CITY OF West Linn

Re: DR-15-01 Design Review Adult Community Center Responses to incomplete notice

WEST LINN ADULT RECREATION CENTER
1180 Rosemont road West Linn, OR

VICINITY MAP

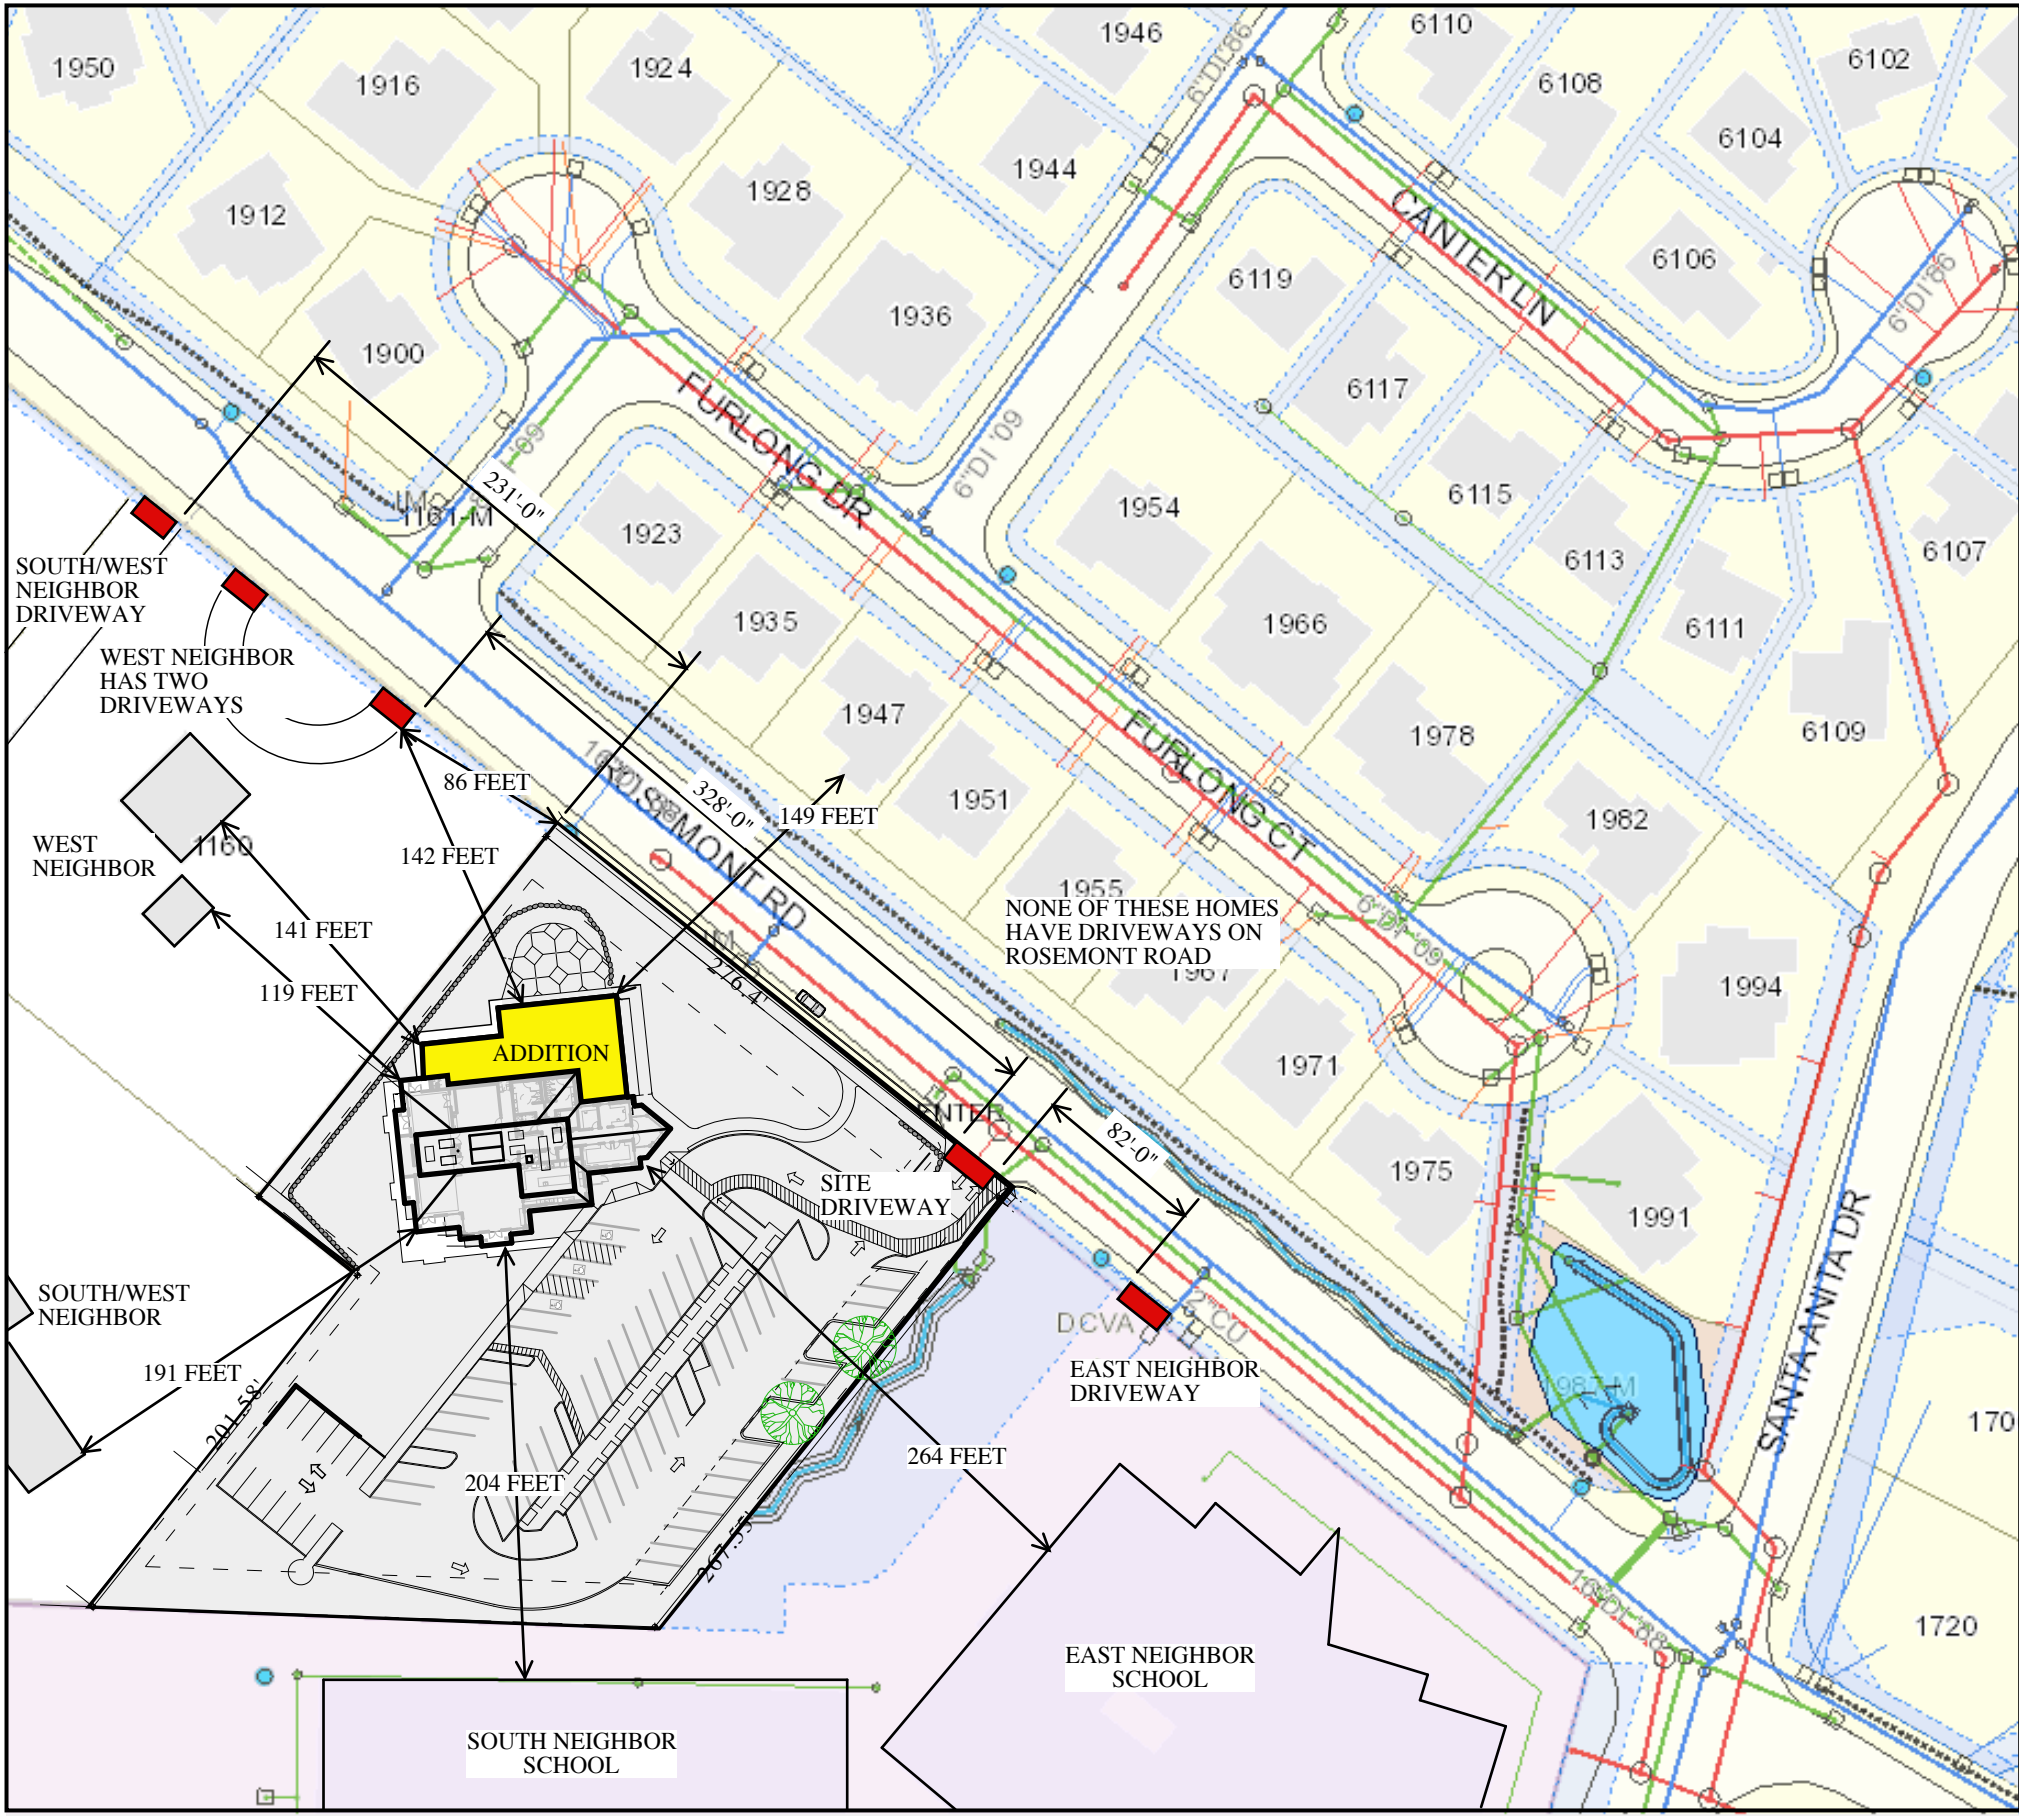
CDC 55.120(F)(2)

Revised Site plan (labeled Vicinity Map) now shows existing structures and driveways on adjoining properties.

SHEET
A1
OF 4

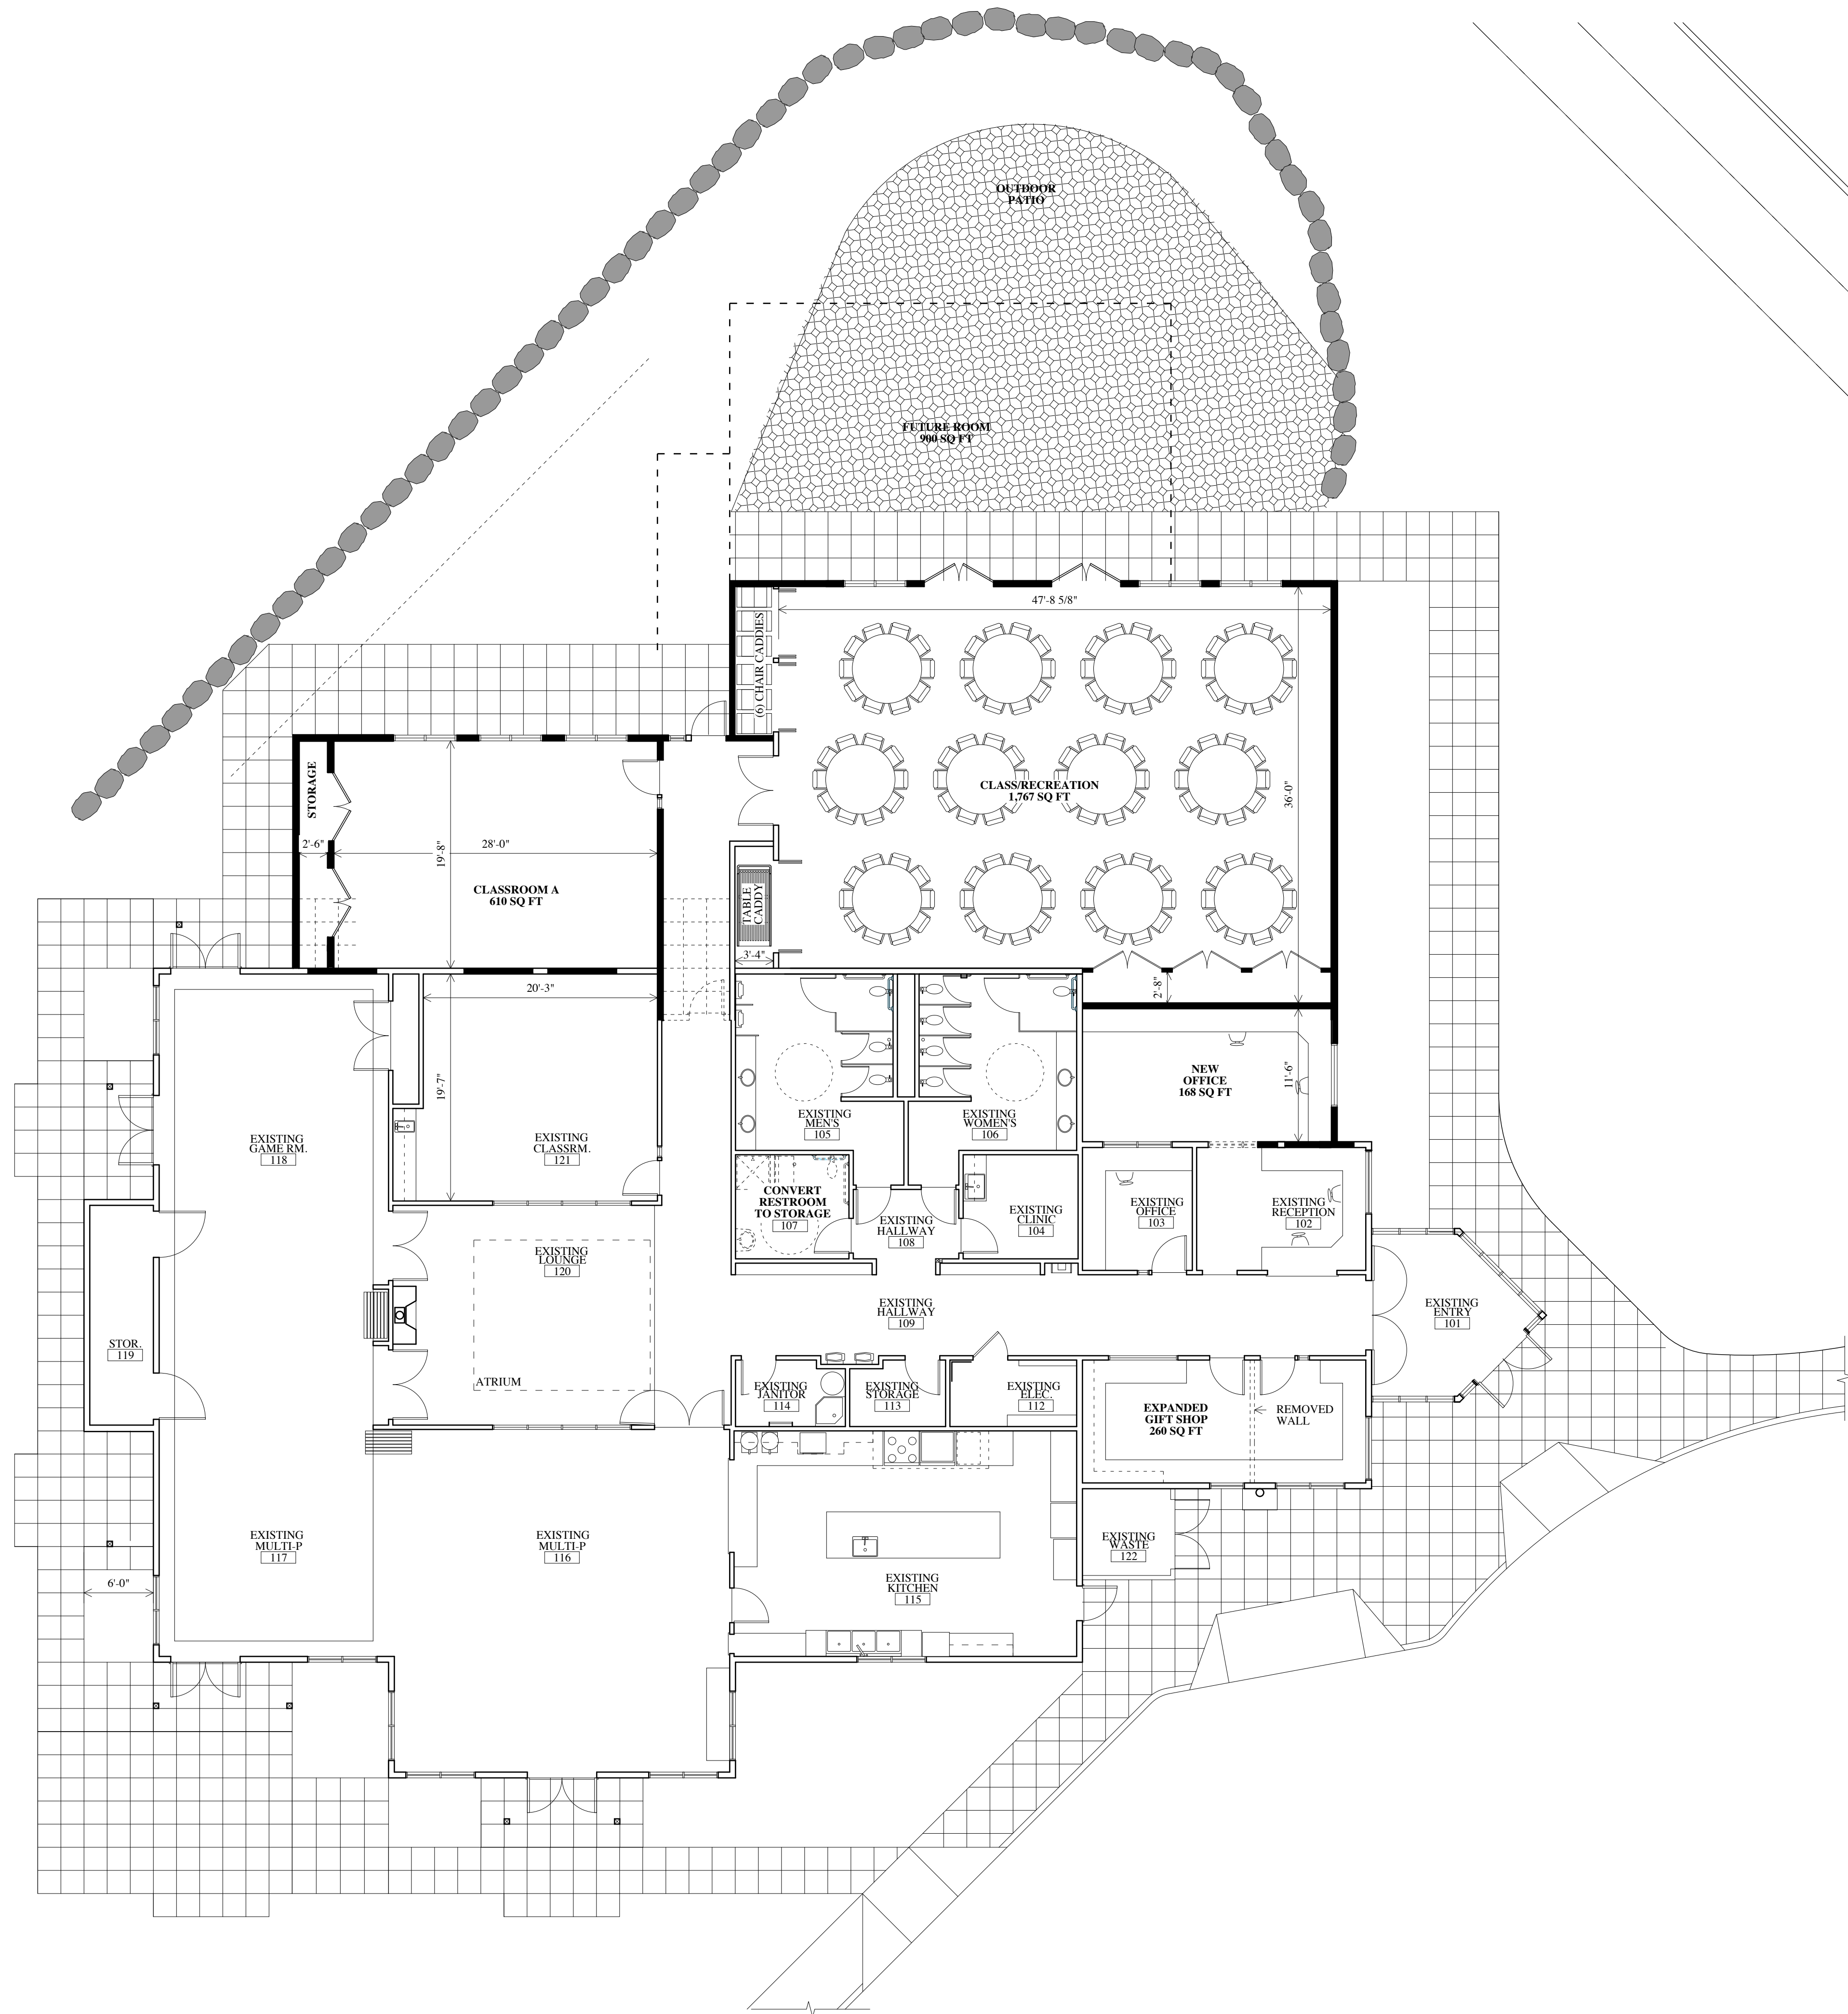
CDC 46.090(B)(15) and 46.090(F)

CDC 46.150(A(20)) and 55.100(B)(7)(d)

The new sheet A1 submitted shows a reduction in parking to the allowed 67 spaces.

The new sheet A1 submitted shows an additional internal path for new parking spaces, next to space 'B48'.

LANDSCAPE PLAN
NOT TO SCALE

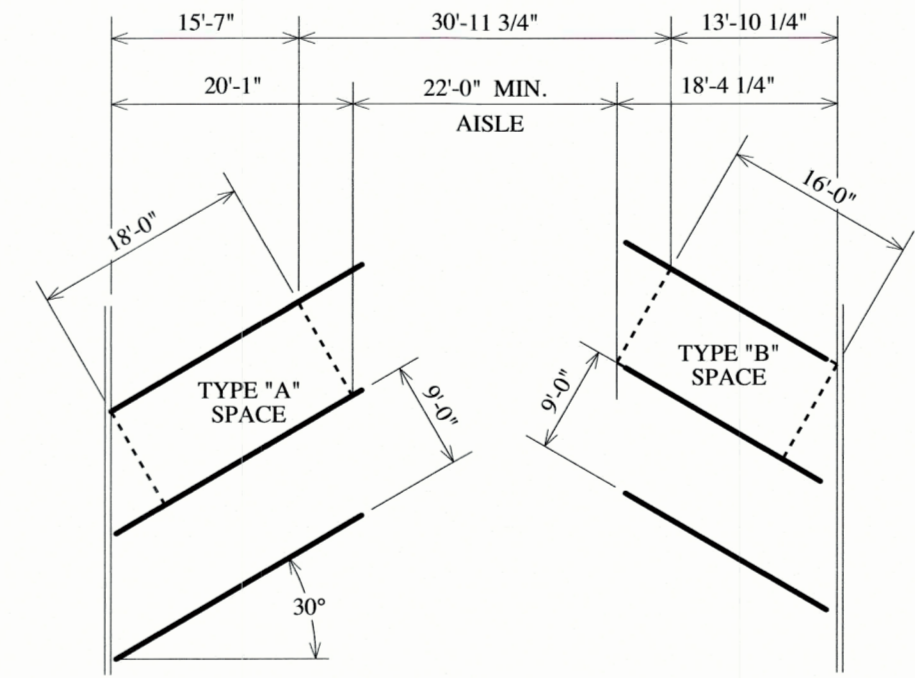
CDC 55.070(D)(2)(e), 55.150, 54.020(E)(3)

CDC 55.100(B)(6)(e)

The landscape plan sheet shows the plan for the additional parking areas consisting of low shrubs to match the existing landscape plants (pictures included as samples of existing landscaping). The landscape plan shows that the new pervious parking area is credited as 25% landscaped and the new impervious parking spaces have 21% of the interior parking area landscaped. There are two trees that are being saved in parking islands as shade trees for the new parking area. A five foot landscaped buffer exists between parking area and property line.

The landscape plan sheet shows additional landscaping that will be in front of the addition to the east elevation to provide some relief from the proposed blank wall. (see pictures submitted for sample existing landscaping)

SITE PLAN
LIGHT COVERAGE

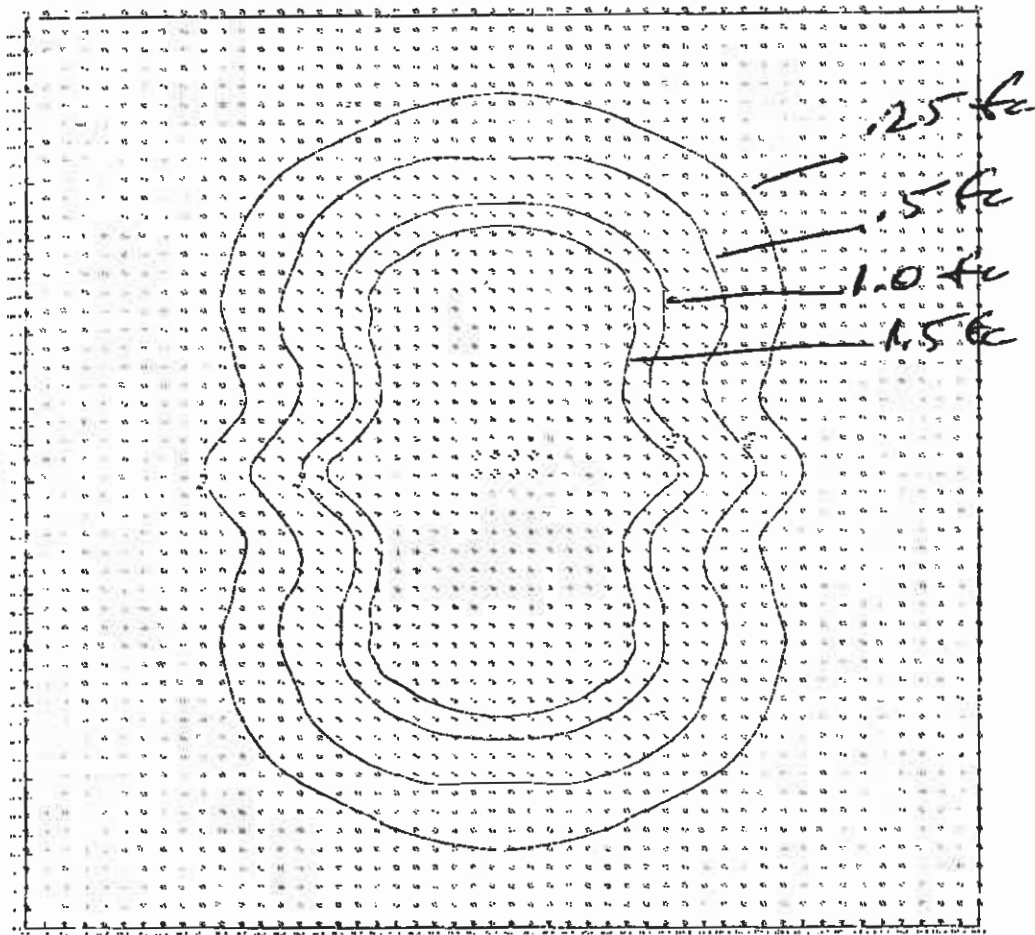
CDC 55.070(D)(2)(g)

Light coverage plan with photometric data is provided from the original application. No new lighting is proposed with the current application.
